Planning Commission
AGENDA OF JANUARY 10, 2023
POLICE DEPARTMENT TRAINING ROOM
7:00 PM

1. **PPZ2022-0156: Lorain County Health & Dentistry, 35557 Center Ridge Rd, PPN 07-00-021-117-086, 07-00-021-117-088**
Applicant: Christine Raymond, Kaczmar Architects, Inc., 1468 W. 9th St, Suite 400, Cleveland, OH 44113. Proposal consists of constructing a medical/dental office building. Property is zoned B-3 Highway Commercial District.

NEW COMMUNITY HEALTH CENTER
35557 CENTER RIDGE RD
NORTH RIDGEVILLE, OHIO 44035

ELECTRICAL SITE AND PHOTOMETRIC PLAN

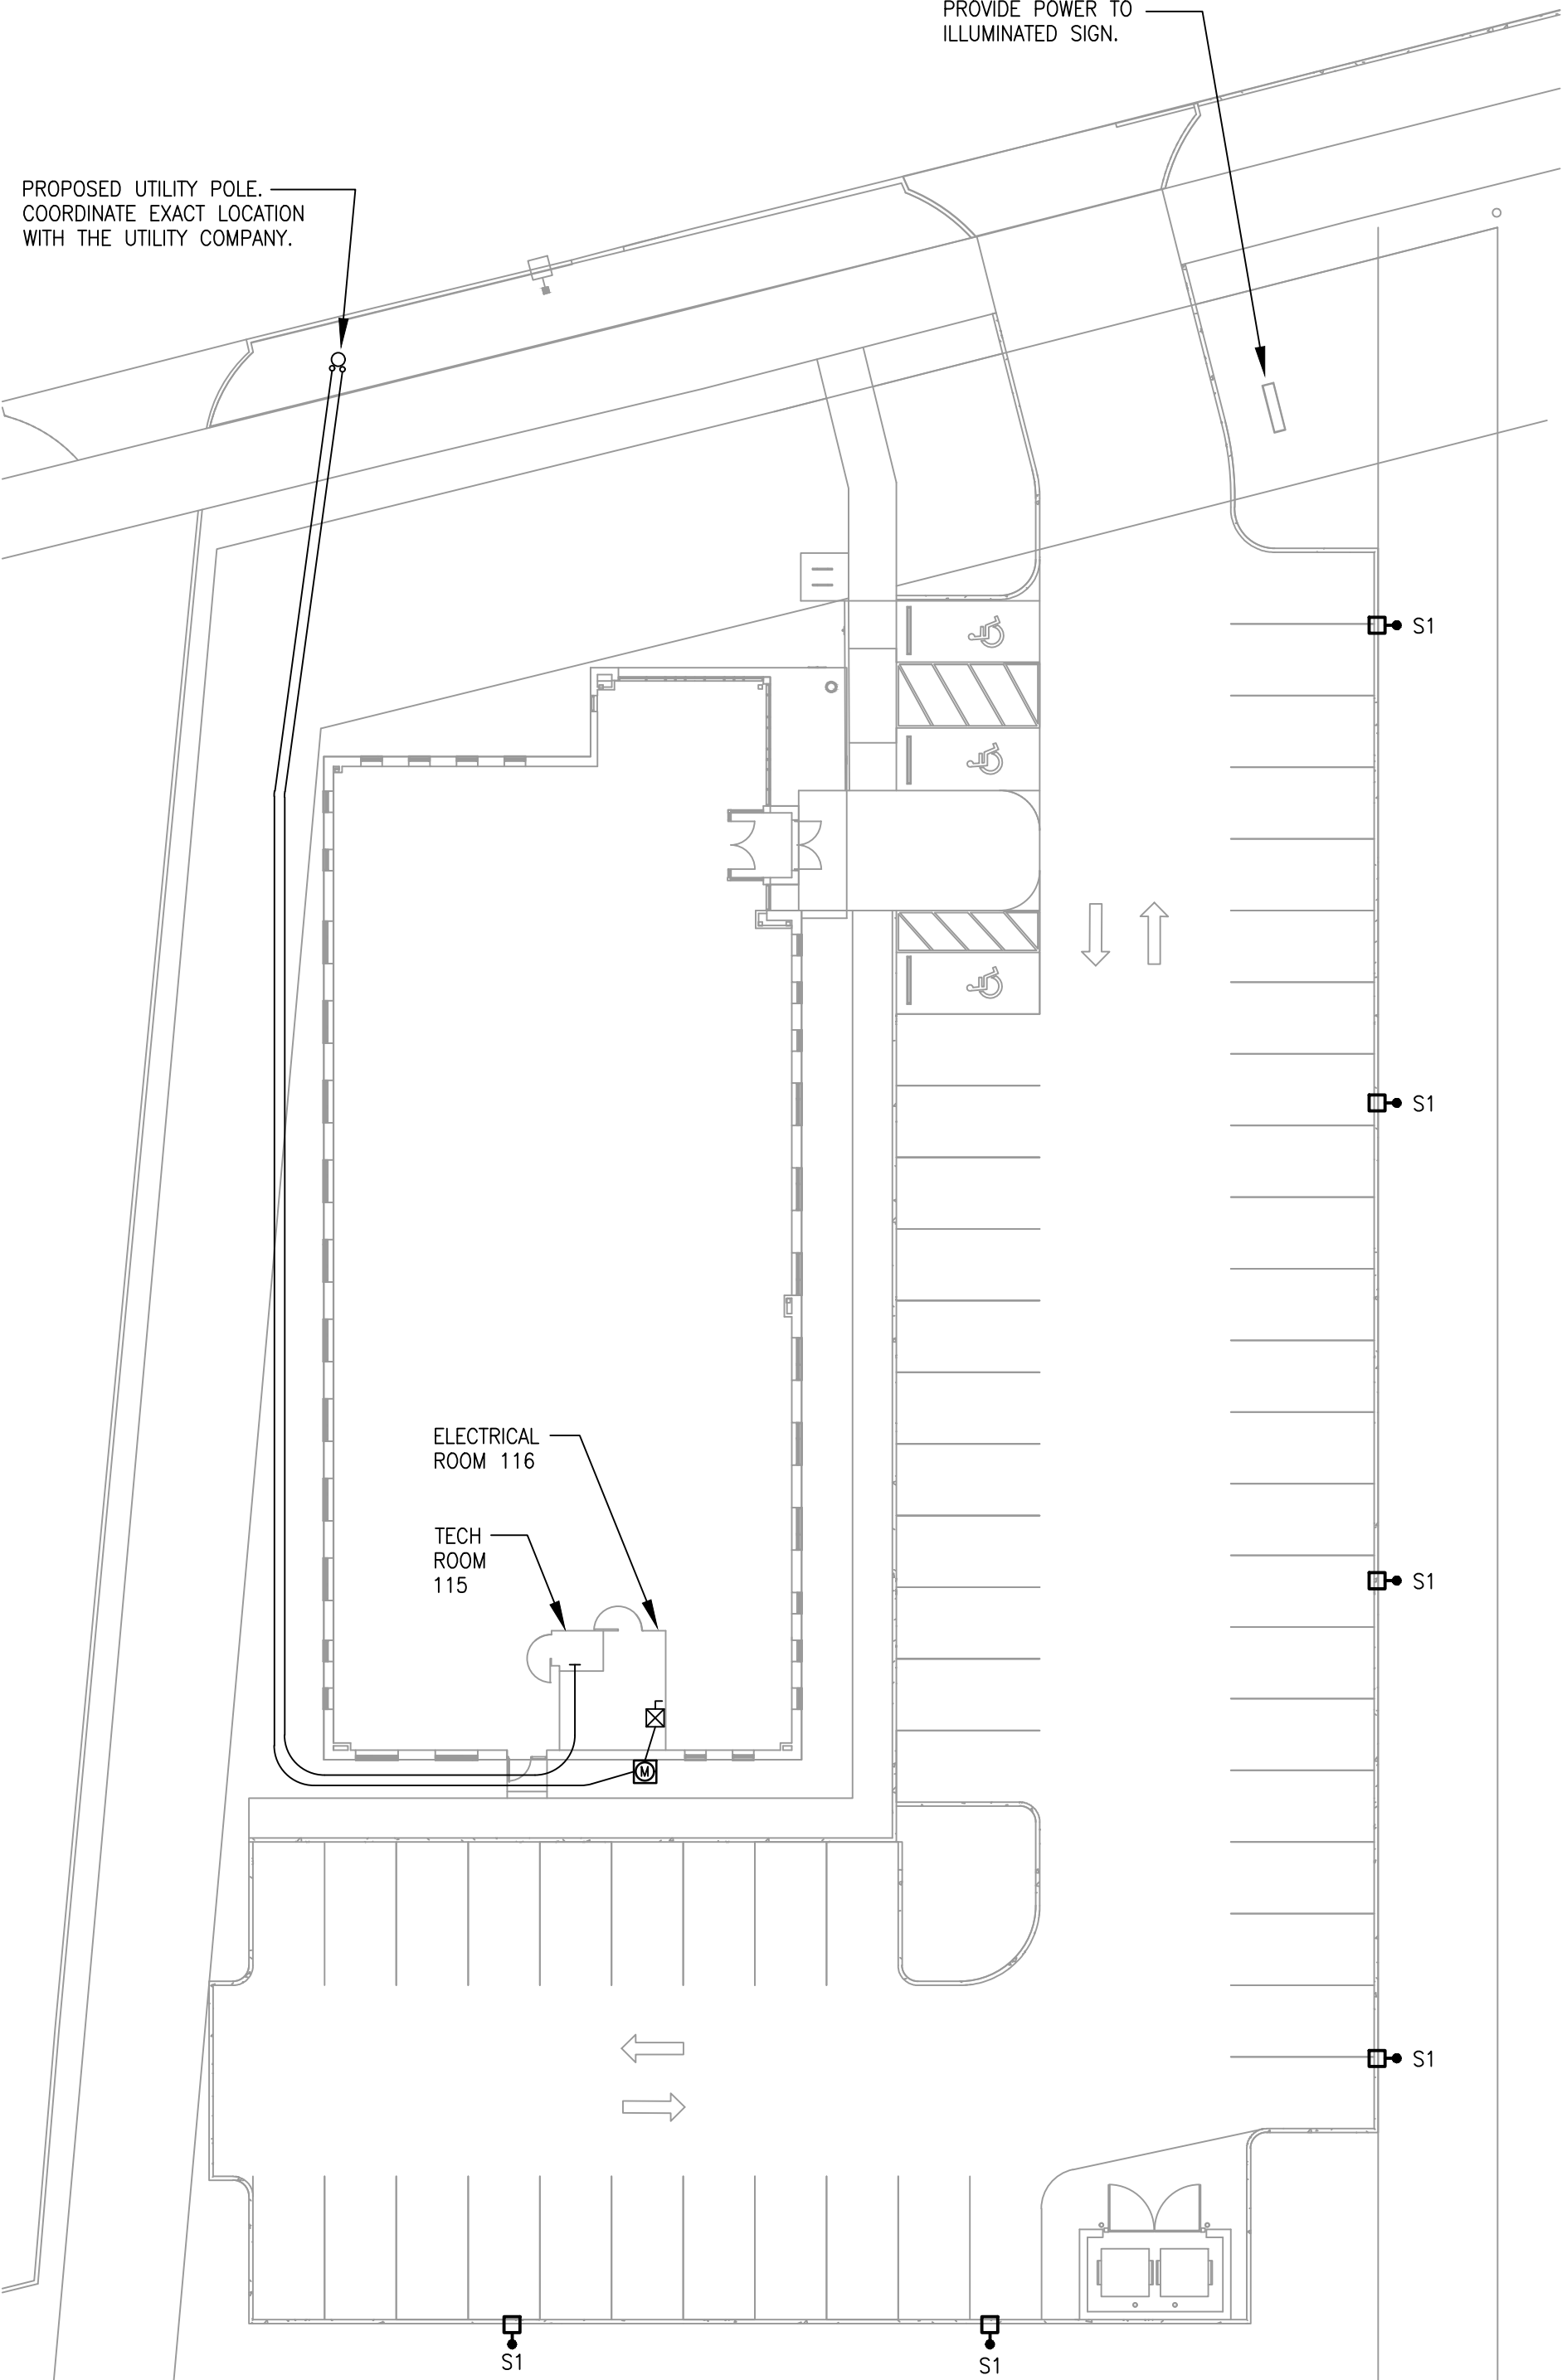
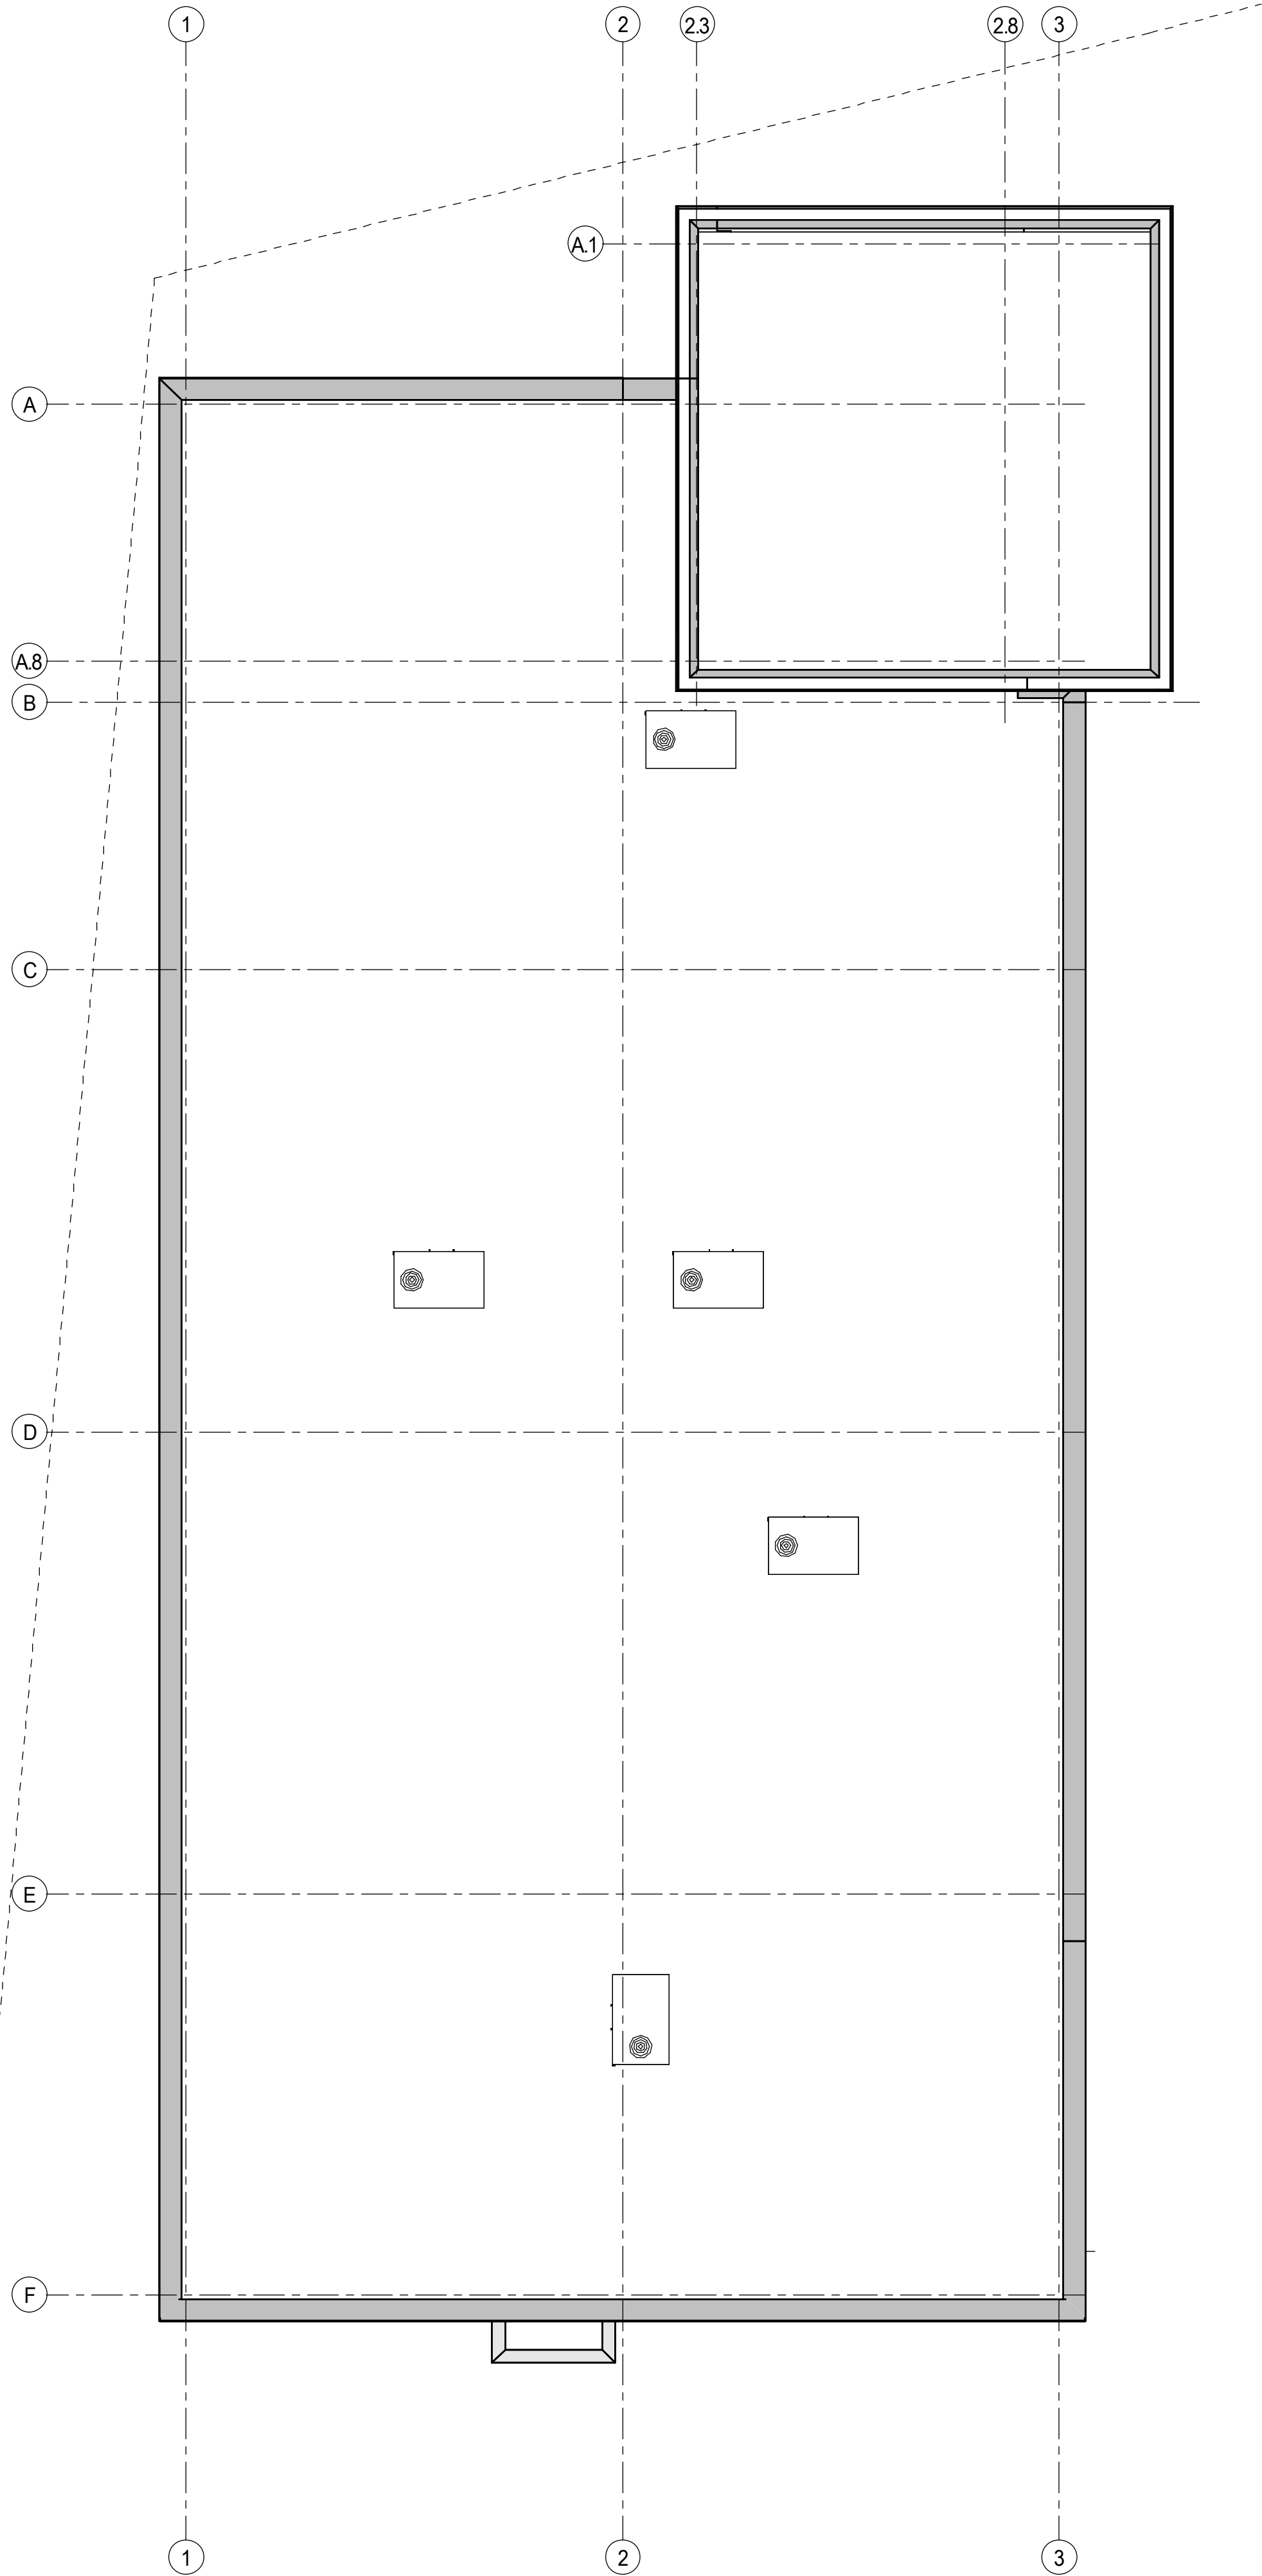
- Provide cut sheets of building lights and update photometric plan with all on-site light sources.
